## CENTREVILLE PLANNING COMMISSION

- V. **Citizen Comment** (*Citizens are requested to keep their comments to three minutes*)
- VI. **Appearances**
  - a. Preliminary Site Plan Submittal – 216 N. Commerce Street, Mixed-Use Building; Tred Avon Partners, LLC, Owner; Steve Layden, P.E., LEED AP, Dumb Home, LLC

**RE: Site Plan Planning Commission Submittal – Tred Avon Partners, LLC  
216 N Commerce St Mixed-Use Building**

## 216 N COMMERCE ST MIXED-USE BUILDING SITE, SEC, STORMWATER MANAGAGEMENT, AND UTILITY PLANS

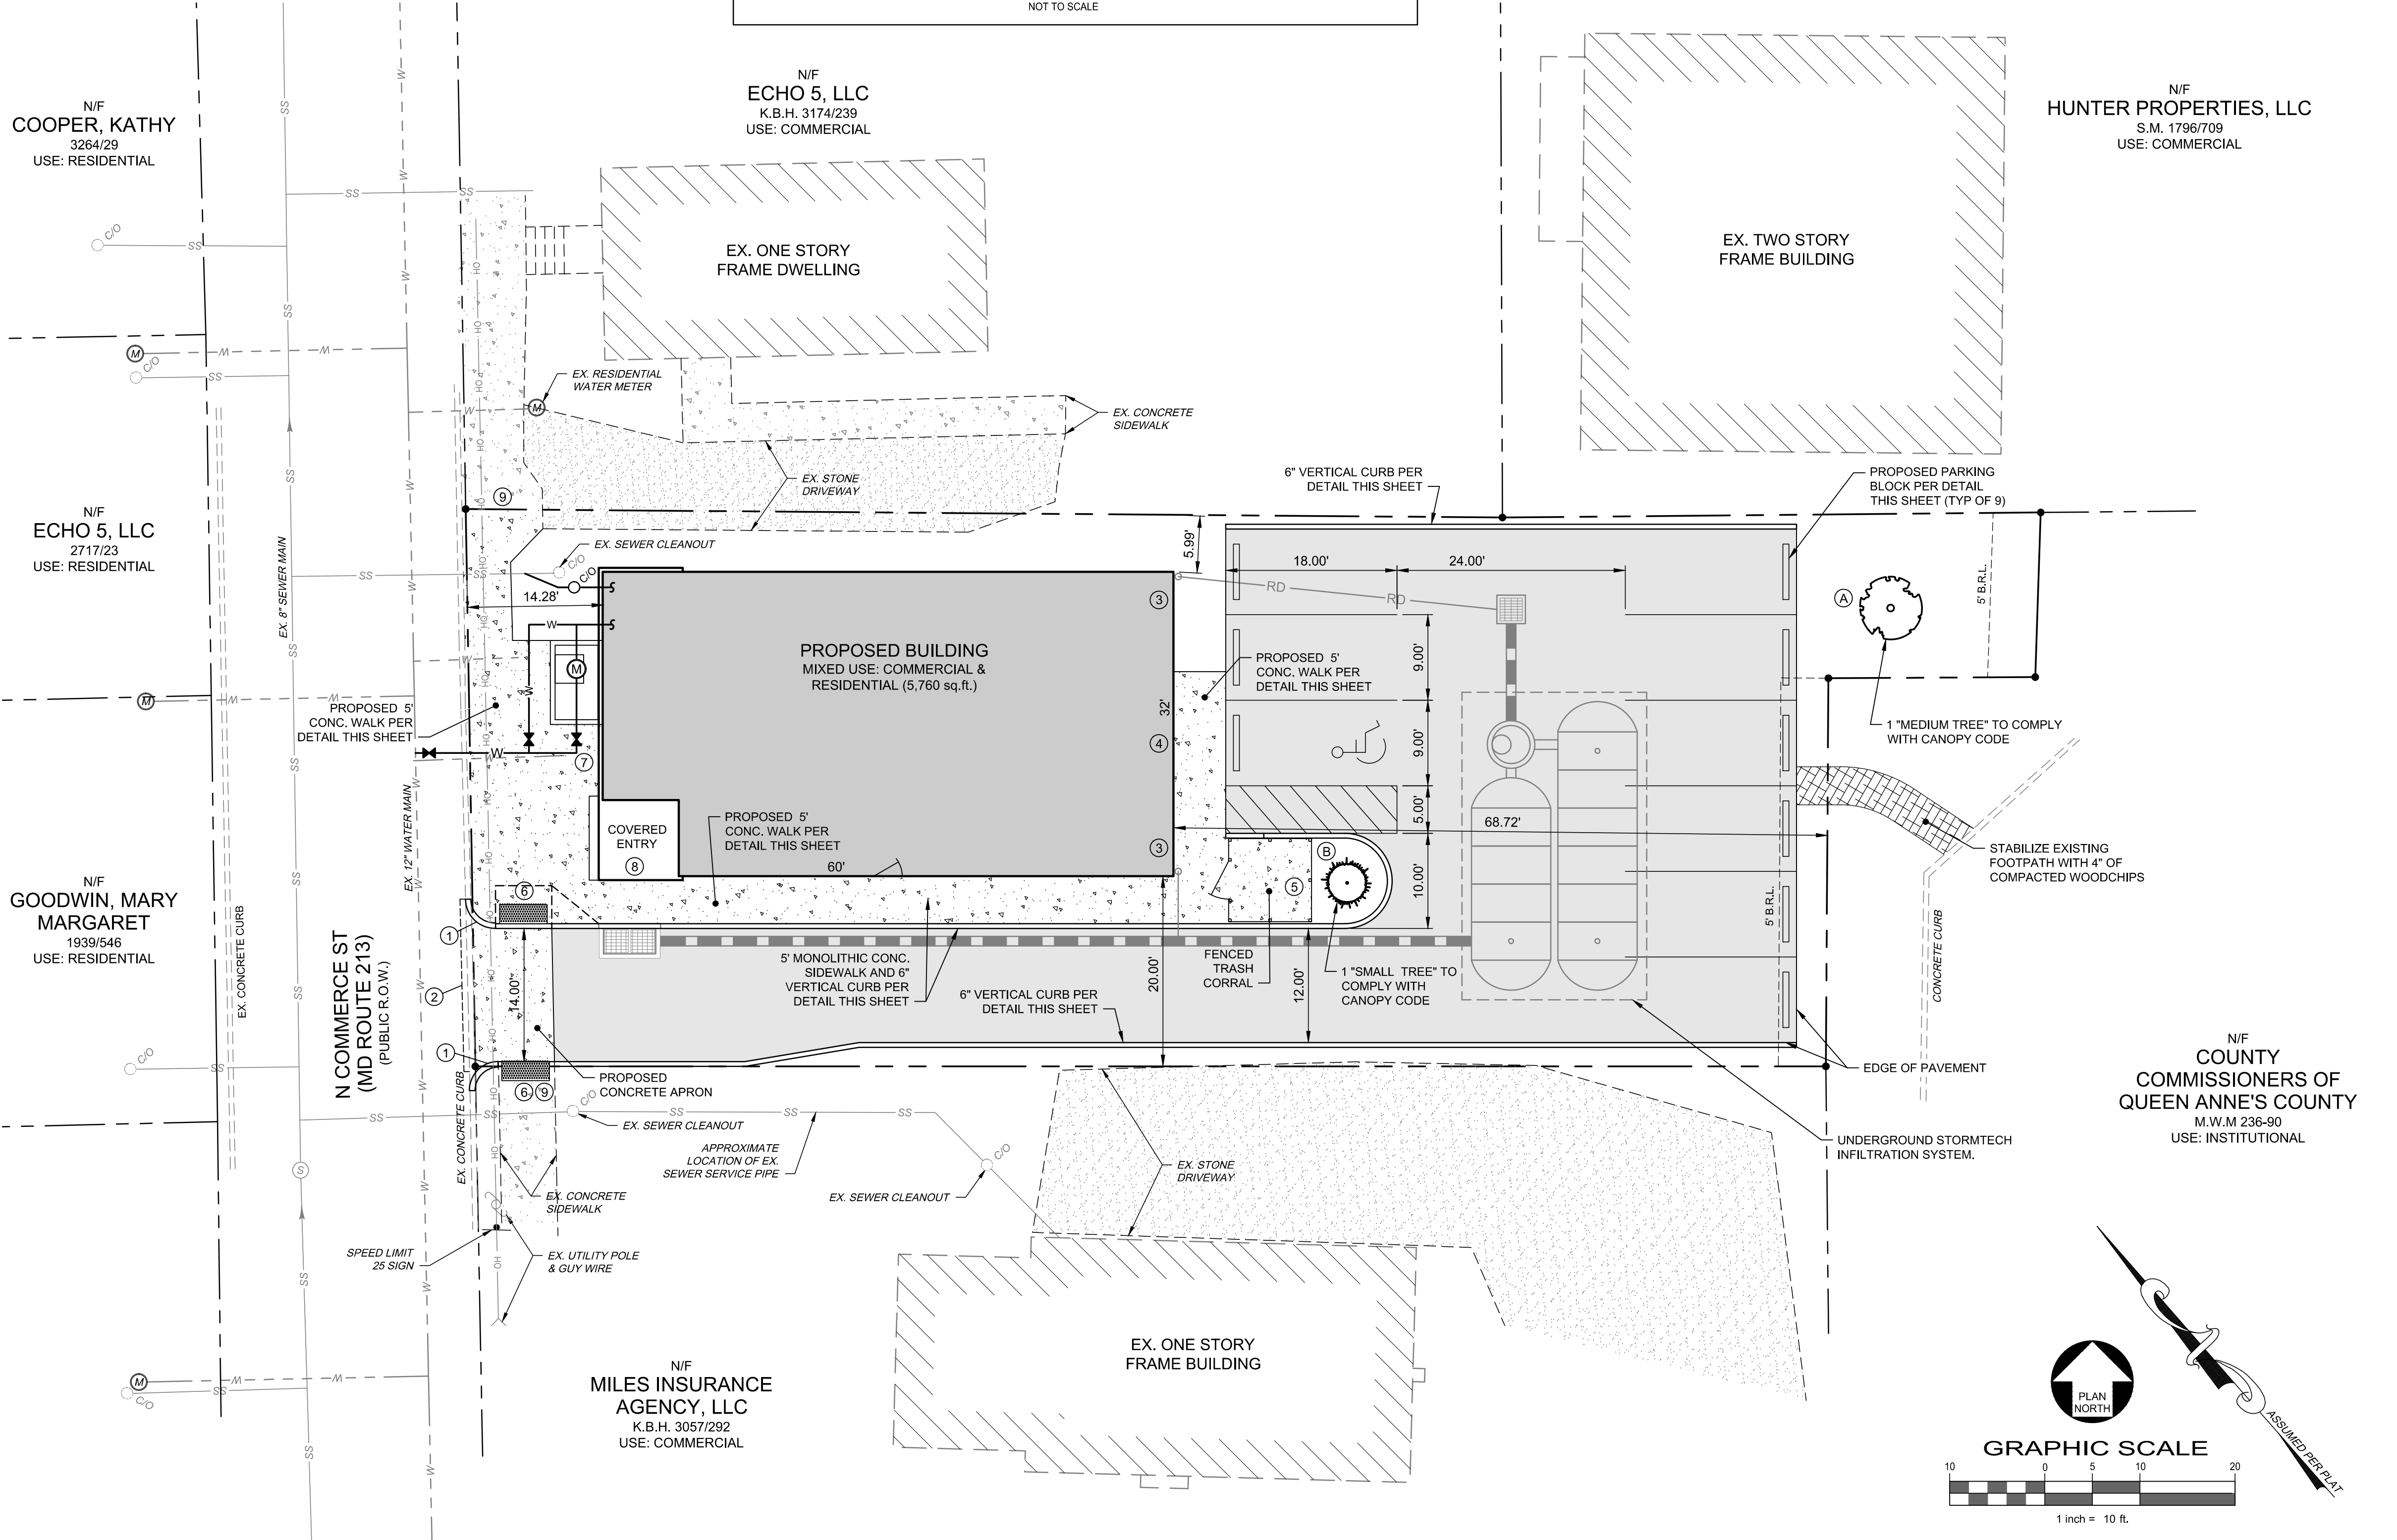
- a. As noted in the Town of Centreville Zone of Regulations, the rear yard in CBD zoning is required to be five feet. As depicted on sheet 3 of 9, the edge of pavement and the parking blocks appear to extend into the rear yard in 4 ¼ of the six spaces currently proposed along the east side of the parking area (from the SE corner extending toward the lot bump out in the NE corner).

- c. §138-48 B Article IV Specifications and Design Considerations, for Streets, Roads and Improvements, Off-Street Parking indicates that “No driveway serving a parking facility shall be closer than five feet to a side property line.” It is unclear how the proposed drive aisle from Commerce Street entrance to the proposed parking area (Sheet 3 of 9) is consistent with this requirement.

g.	Location, size, and type of all signs;	See Site Plan Sheet 3 of 9 No Parking Sign Detail provided, noted to be installed along building wall (assume along the entrance to

parking area)– we should clarify locations? Additionally, Site note 4 indicates the Handicap Parking sign, also to be fastened to the building wall, says per detail on this sheet (assume that means same notes as the same 3 notes provided for No Parking Sign Detail?)
h	The location, size, and type of vehicular entrances to the site;	Site Plan – sheet 3 of 9, fourteen feet predominately one way drive aisle. Applicant notes in cover letter that exiting cars would have the right of way, suggest signage be considered to note that.
i	The location of the Critical Area District boundary, the Buffer and other Buffer areas, open space areas, and forested areas;	NA- This property is not in the Critical Area.
j	The location of all Habitat Protection Areas (CA only);	NA

RESPONSE: Thank you for mentioning the availability of the parking deck. We believe that between the on-site parking, the parking deck, nearby on-street spaces near Courthouse Square, and the proximity of the Department of Health parking lot, adequate provisions have been made. Please note the addition of a woodchip path in the location of an existing informal pathway between the subject lot and the DEH parking lot on Sheet 3 of the site plan.

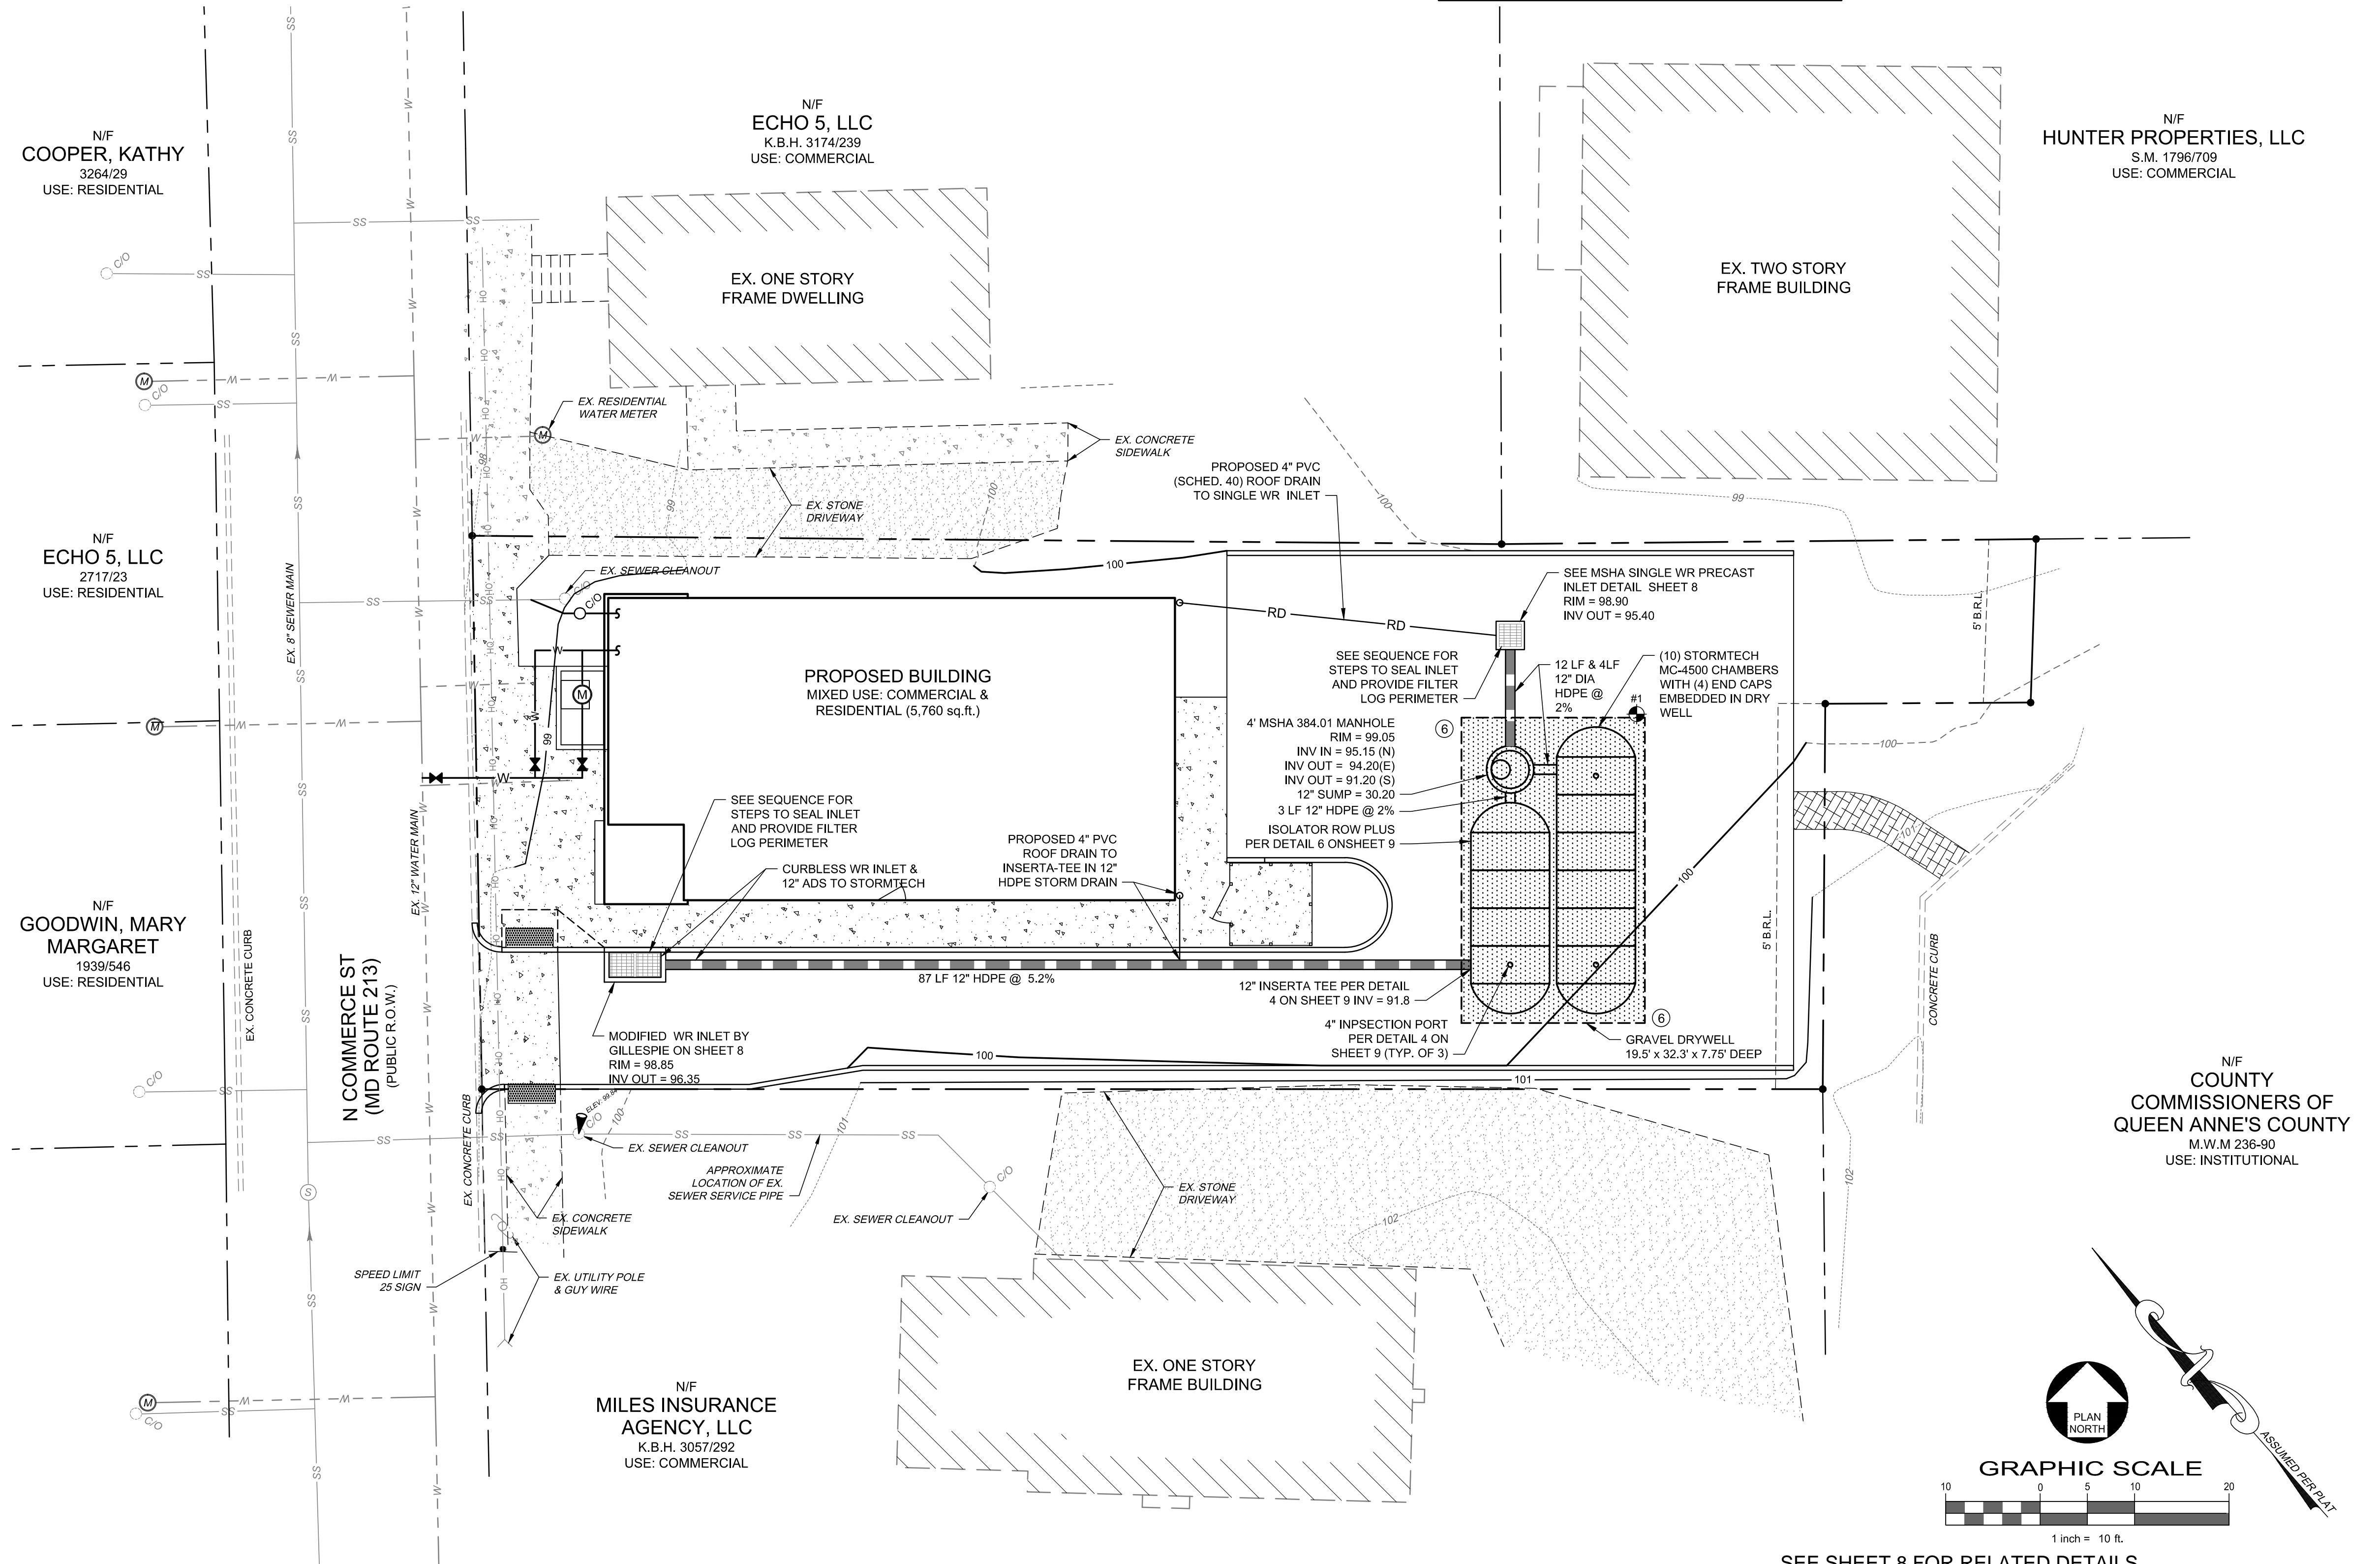
9. 4" meter vault detail including in & out stenciling.

RESPONSE: The town provided a 6" meter vault which is shown on Sheet 6. We have added a note to stencil on the flow direction. We are looking into whether a 6' service line and meter is required or whether 4" would be adequate. If we're able to go with 4", we talked with Gillespie precast, and they believe the meter vault could be shrunk to 4 ft x 6 ft inside. In either case, we would prefer the headroom in the vault to be approved at 6 ft rather than the 7 ft currently shown. With space at a premium in the front yard, the vault currently sits on the foundation footer directly adjacent to the basement foundation wall. With a vault that provides 7 ft of headroom (8'-2" tall), the vault would interfere with the siding and waterproofing on the front of the building. A lower vault means the top slab sits down below the siding. We look forward to finalizing these details later in the approval/permitting process.

RESPONSE: Thank you for that information, we have updated the notes on sheet 6 accordingly.
